Mt Piper Power Station Extension

Submissions Report

SUBMISSIONS REPORT

Figure 2-1 Predicted change in the number of hours above 570 µg/m³ (SO₂)

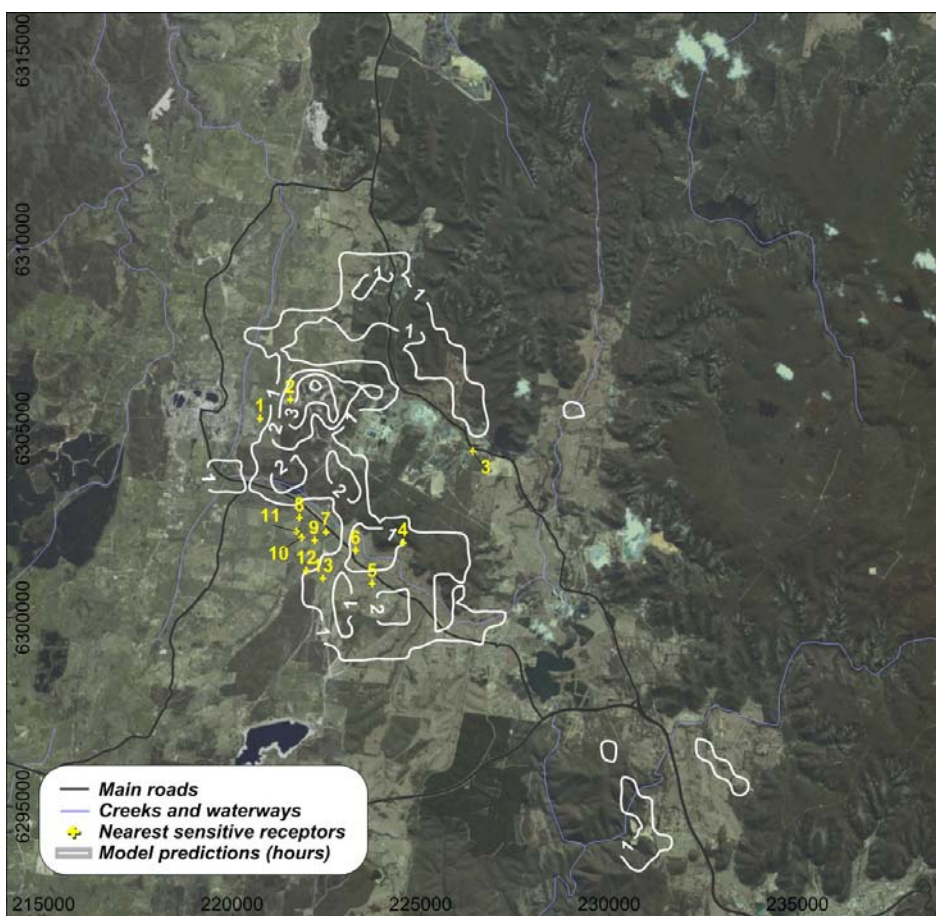
In most cases, the assessment modelled actual (existing and proposed) emissions rather than POEO Regulation limits. The existing Mt Piper power station emits NO_x, at a greater concentration than the POEO Regulation limit for Group 6 plant, namely 500 mg/m³. As such, the assessment modelled NO_x, emissions at the regulation limit for the proposed coal fired option.

With respect to SO₂ Figure 2-1 shows the potential for additional exceedances of air quality criteria (1 hour SO₂ = 570 µg/m³) from Mt Piper Extension USC 4 units. Also shown are nearest residential receptor locations.

The SO₂ emission concentration will be a function of the sulphur content of the coal, and as can be seen in Table 2-2, average SO₂ concentrations in 2009 (1180 mg/Nm³) are consistently higher than the 900 mg/Nm³ estimated from modelling as the level needed to ensure no additional exceedances of SO₂ ambient air quality criteria within sensitive receiver areas. If an SO₂ limit of 900 mg/Nm³ was placed on the proposed Mt Piper Extension USC plant, this would restrict the coal able to be used in the plant to lower sulphur coal than is currently used, assuming no other pollution controls are available eg. FGD.

Given the small number of additional exceedances (less than 2), the limited number of potentially affected receivers and the fact that the analysis is based on theoretical modelling, imposing SO₂ emissions limits (i.e. restricting the coal supply on the basis of sulphur content) is not considered a realistic or practical approach to managing potential future air quality (SO₂) impacts. A more robust approach may be via a management plan designed to assess the actual impact of the power station, once operational.

Figure 2-2 Predicted NO₂ impacts due to Mt Piper, Wallerawang and Mt Piper Extension (USC)

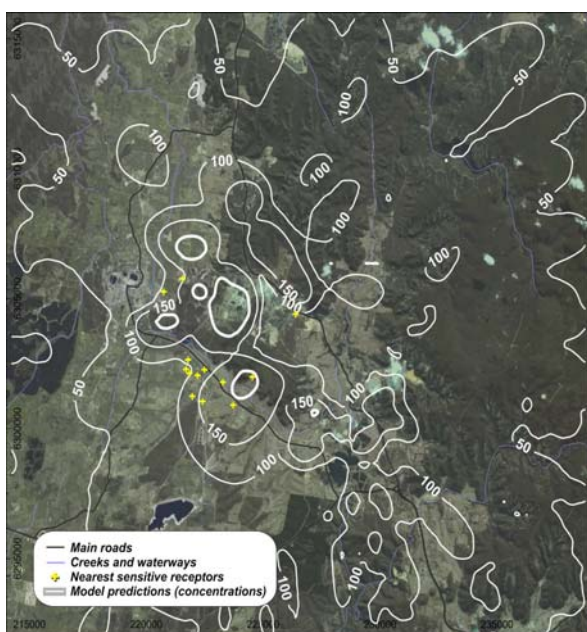
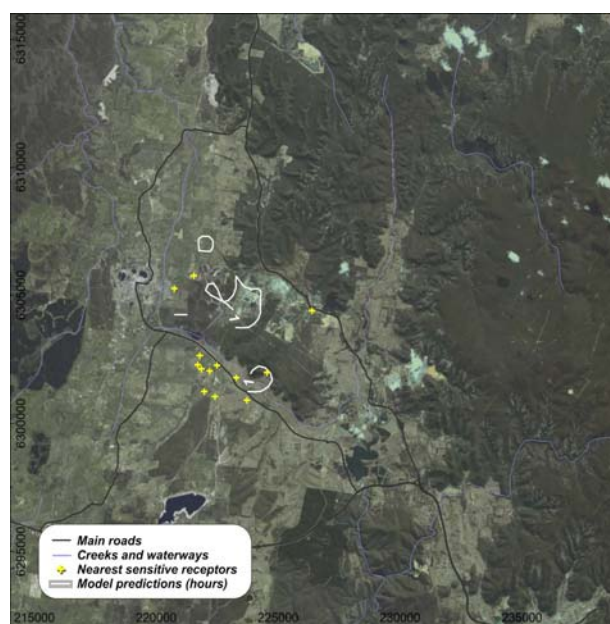
The use of a blanket 30% NO_x to NO₂ conversion ratio is not consistent with the requirements of the DECCW's *Approved Methods*. Accordingly, the proponent should conduct a revised NO₂ assessment using a transformation method that is specified in the *Approved Methods*.

The assessment does not provide cumulative isopleth plots for the modal scenarios that include Mt Piper, Wallerawang and the proposal emissions. Future assessment for the proposal should include isopleth plots for all cumulative scenarios assessed.

Figure 2-2 shows the cumulative isopleths for the model scenario which includes Mt Piper A, Wallerawang and the proposed Mt Piper Extension (USC). These results assume that 30% of the NO_x is NO₂, at the point of maximum 1-hour average ground-level concentration. From the revised NO₂

assessment using OLM and given in Section 2.2.1 above, the maximum 1-hour average NO₂ concentrations will be 248 µg/m³ rather than the 365 µg/m³ maximum that was presented in the air quality assessment. Therefore, the results in Figure 2-2 are higher than expected impacts and the predicted number of hours above the 246 µg/m³ criterion will be essentially zero at sensitive receptor locations.

Figure 2-3 Predicted SO₂ impacts

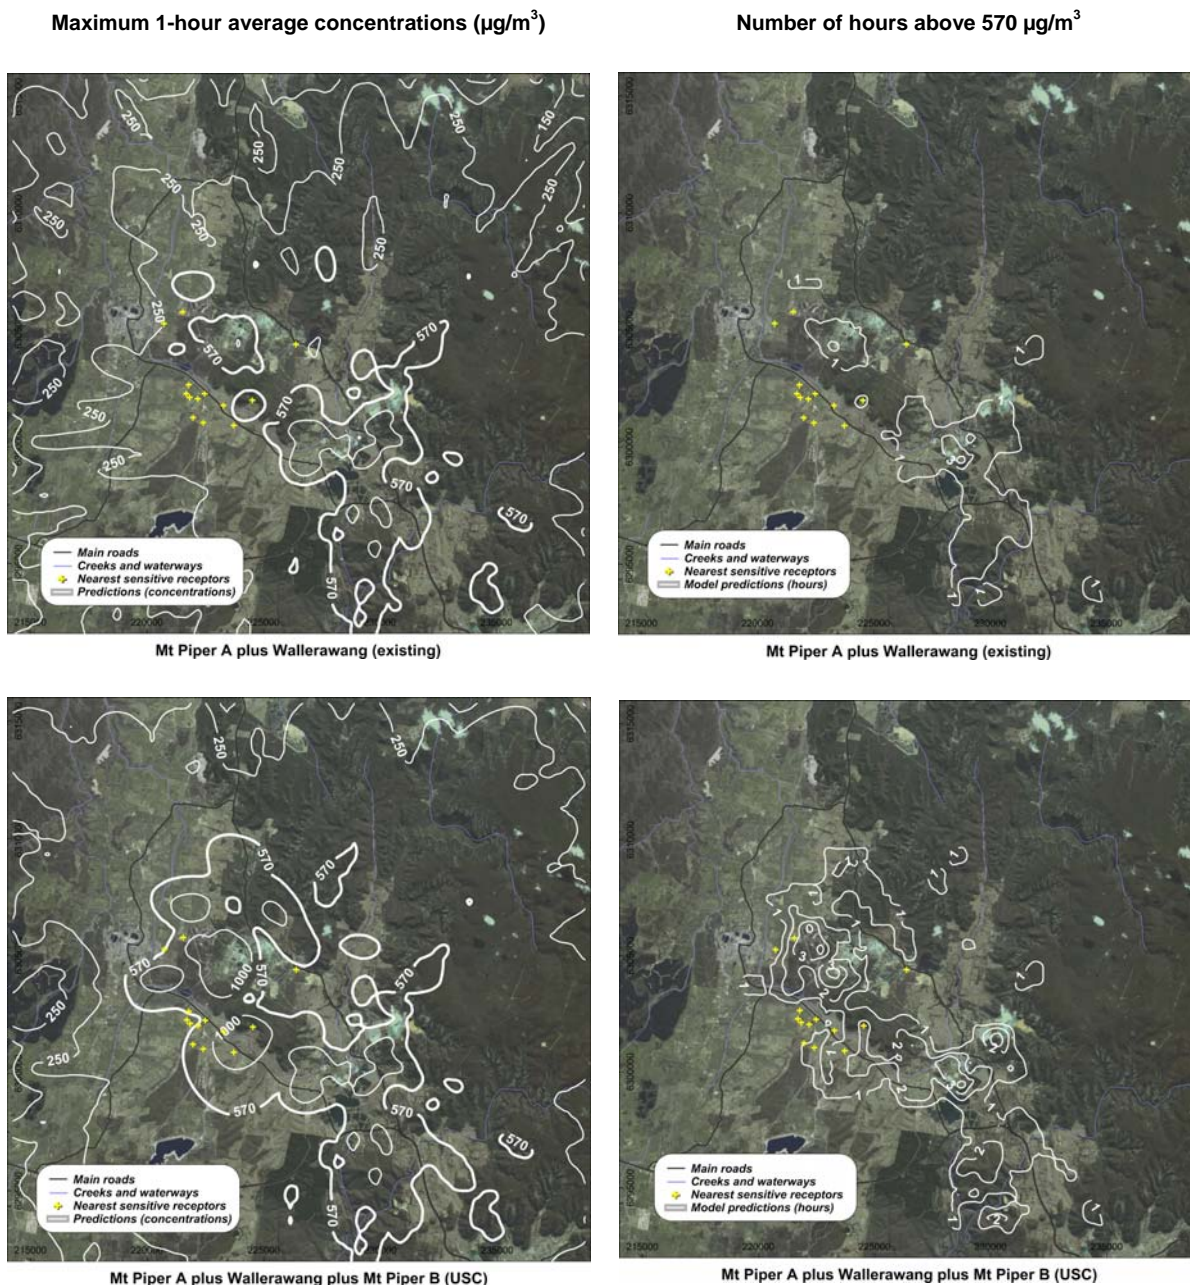
It is likely that the geographical extent of the exceedance hours would increase for the coal fired option. However, the assessment does not provide cumulative isopleth plots for the model scenarios that include Mt Piper, Wallerawang and the proposal emissions. Future assessment of the proposal should include isopleth plots for all cumulative scenarios assessed.

Figure 2-3 shows the cumulative isopleths which include the following scenarios:

Maximum 1-hour average SO₂ concentrations are presented, as well as the predicted number of hours above 570 µg/m³. It can be seen from this figure that the spatial extent of maximum 1-hour average SO₂ concentrations is predicted to increase when the Mt Piper Extension added to the existing sources. Also, the extent of areas above the 570 µg/m³ criterion is predicted to increase. The maximum number of hours above 570 µg/m³ is predicted to remain unchanged at 5 per year (Table 13 of air quality assessment). This maximum is dominated by the Wallerawang sources.

■ **Figure 2-5 Location of Registered Aboriginal Sites**

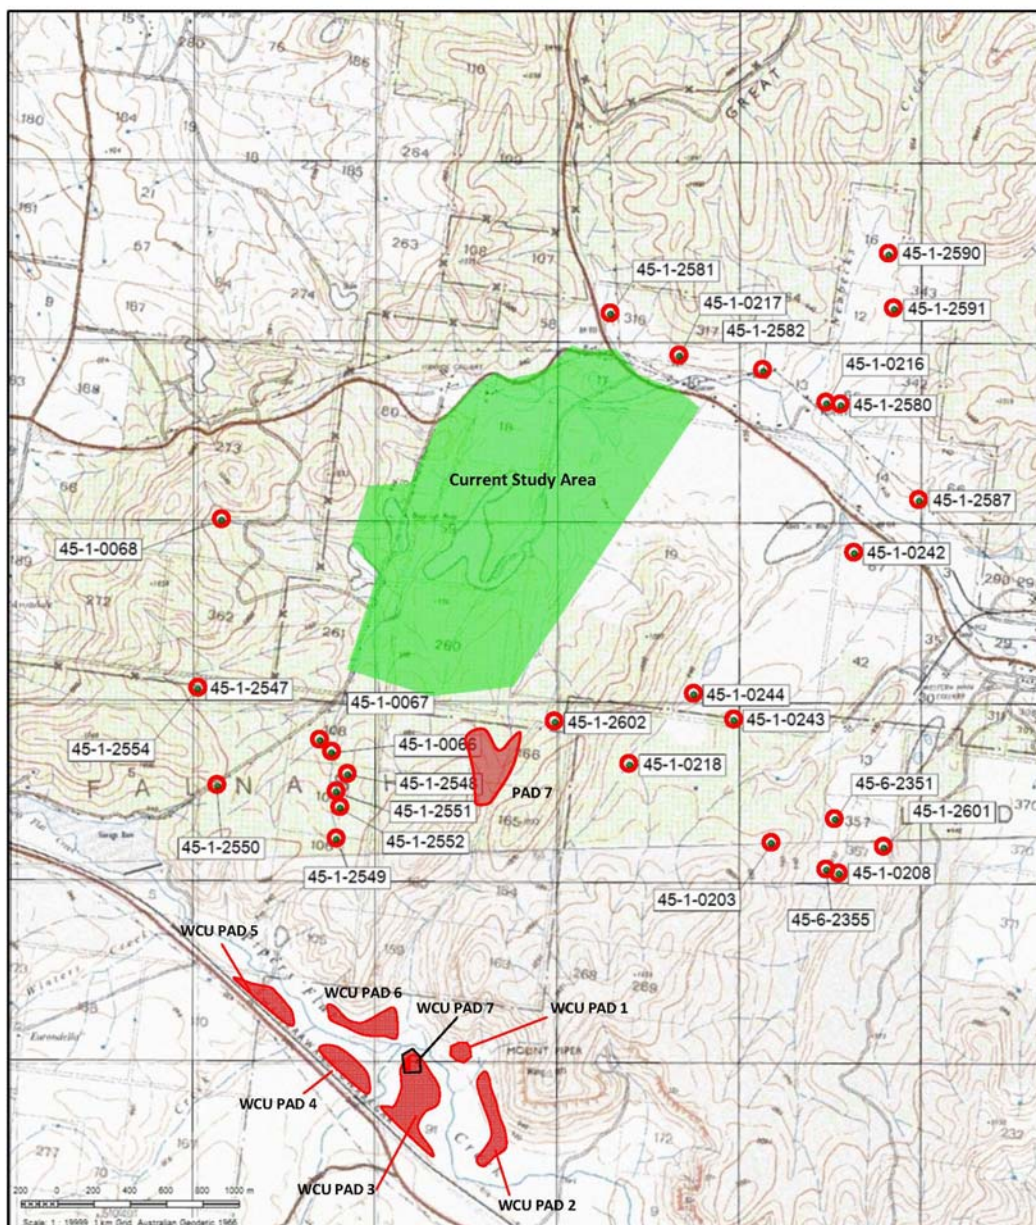
Figure 1 within the main body of the EA (Chapter 7 Volume 1 • Main Report), indicates the locations of registered Aboriginal sites in the study area. The locations mapped are not accurate and, in some cases, are mapped 10km from the actual recorded location in DECCW Aboriginal Heritage Information Management System. The proponent should correct this map to ensure all sites are plotted at their actual location.

A modified map showing sites is shown in **Figure 2-5** below.

■ **Figure 2-6 Surveyed areas**

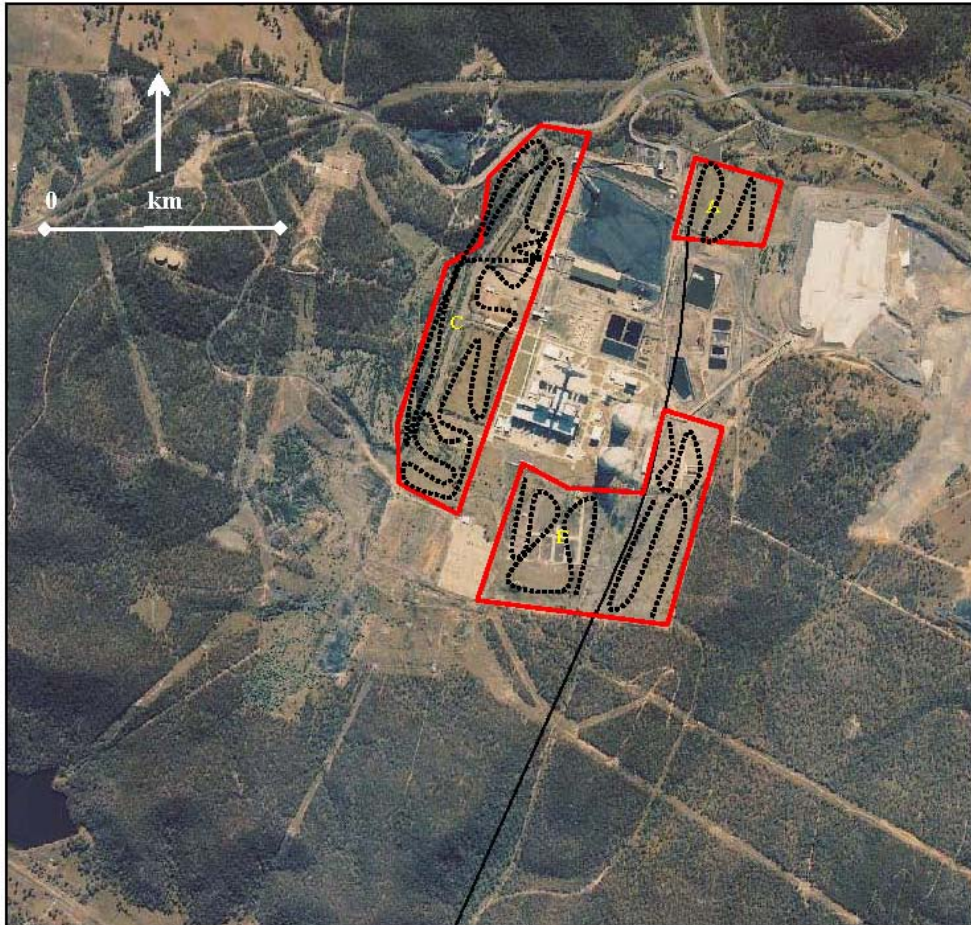
DECCW notes Appendix C states that Aboriginal stakeholders did not participate in the field inspection due to the highly disturbed nature of the site. However, DECCW understands that the Aboriginal Community were told they were not allowed to participate in the field visit due to safety and access issues despite the site being accessible to the archaeologist who undertook the field inspection. The proponent should provide an opportunity for all Registered Aboriginal stakeholders to inspect the site.

The areas surveyed are shown in Figure 2-6 below. The dotted lines show the path covered by the archaeologist and assistant. All landform units within the study area were surveyed.

Figure 2-7 Predicted SO₂ impacts

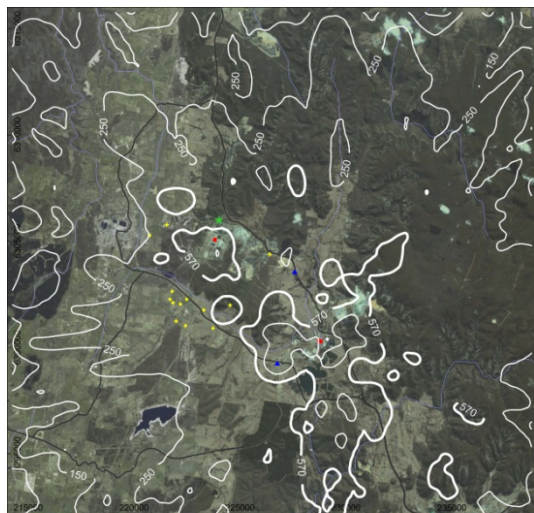
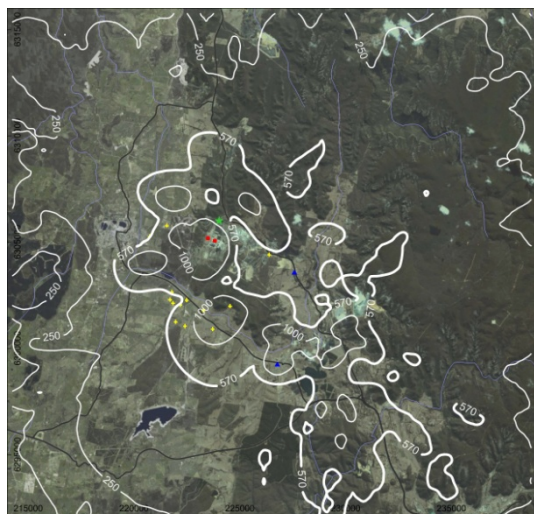
The modelling provided predicts that the 10-minute and 1-hour sulphur dioxide impacts from the USC plant will exceed the existing Mt Piper impacts, particularly at Wallerawang (Table 13). The distribution of the impacts for the worst hour of the modelled year are shown in Figure 13. This demonstrates that significant increases in sulphur dioxide exposure from Mt Piper are expected over the same region most impacted by Wallerawang power station emissions, which is around the township of Wallerawang. Unfortunately the figure provided does not include the cumulative impact of all three sources.

Figure 2-7 shows the cumulative isopleths which include the following scenarios:

Maximum 1-hour average SO₂ concentrations are presented, as well as the predicted number of hours above 570 µg/m³. It can be seen from this figure that the spatial extent of maximum 1-hour average SO₂ concentrations is predicted to increase when the Mt Piper Extension source added to the existing sources. Also, the extent of areas above the 570 µg/m³ criterion is predicted to increase. The maximum number of hours above 570 µg/m³ is predicted to remain unchanged at 5 per year (Table 13 of air quality assessment). This maximum is dominated by the Wallerawang sources.

■ **Figure 3-1 NSW Summer Demand Outlook (from ESOO 2009)**

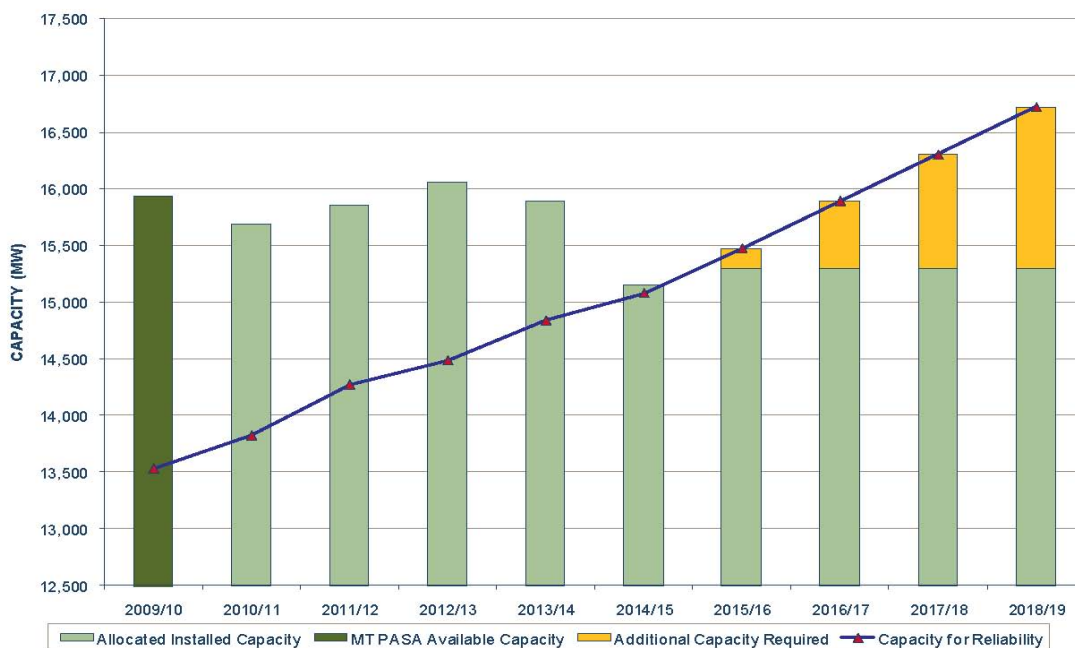
| Submission number | Issue | Submission details | Response |
|-------------------|---------------------|---|----------|
| 62 | Information Quality | Figure 2.3: this shows a summer peak demand of 16750 MW in 2018/19. Given the government's target of 20% from renewable by 2020, and that the current level is only 6% of 16000, that implies an additional 1385 from renewable. That almost meets the anticipated shortfall of 1450. | 3.9 |

The 2009 Electricity Statement of Opportunities (ESOO) published by the Australian Energy Market Operator (AEMO) indicates that additional capacity of 182 MW is required in NSW in 2015/16 based on its demand/supply forecasts. This is the first year that the LRC⁴ indicates a reserve deficit⁵ as indicated in Figure 2.3 of the ESOO (see Figure 3-1) showing the NSW summer supply-demand

outlook. As can be seen the reserve deficit increases to about 625 MW in 2016/17 and about 1,050 MW in 2017/18.
